WCAP-15981-NP, Rev 0 (Non-Proprietary)
Project No. 694

Subject: Pressurized Water Reactor Owners Group

Additional Revisions to WCAP-15981-NP, "Post Accident Monitoring Instrumentation Re-Definition for Westinghouse NSSS Plants," (LSC-0072 R1/MUHP-3038)

Enclosure 1 to this letter provides additional revisions as mark-ups to WCAP-15981-NP that address the additional items contained in Ref. 6, that were discussed during a telecon held on May 25th, 2006 between Bob Palla (NRC) and Bob Lutz and Jim Andrachek (Westinghouse). Please provide these WCAP revisions to Bob Palla.

Figure 2 Process to Determine PAM Instrumentation That Should Be Included in the PAM Technical Specification

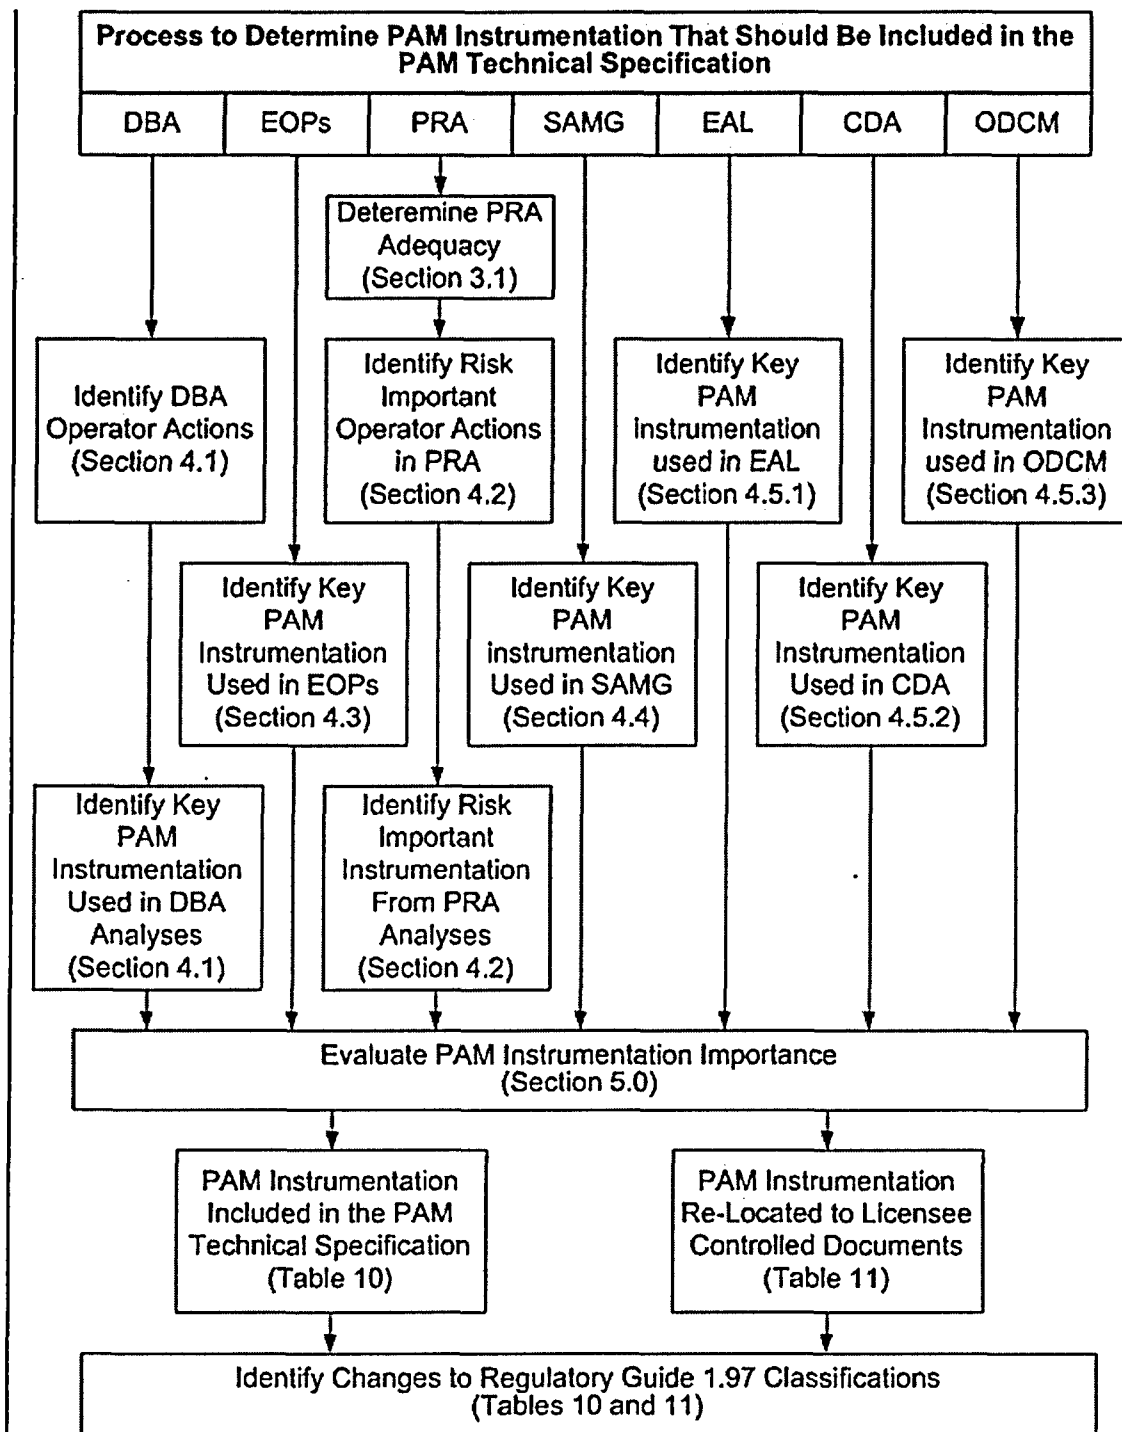
The overall process to be used by licensees to identify the PAM instrumentation that should be included in the Technical Specifications is discussed in Table 14 and shown ~~provided~~ in Figure 2. This process is identical to that described in this report, except that plant specific information would be used in place of generic information to determine the PAM instrumentation to be included in the plant specific PAM Technical Specifications. As discussed in Section 3.2, this is not a risk informed application to be evaluated using the guidance in Regulatory Guide 1.174. The methodology directly assesses the importance of instrumentation with respect to the criteria of 10 CFR 50.36 (c)(2)(ii) rather than focusing on the five elements of a risk informed approach as specified in Regulatory Guide 1.174. The methodology uses risk assessment as one element of the overall method to determine the instrumentation to be included in the PAM Technical Specification.
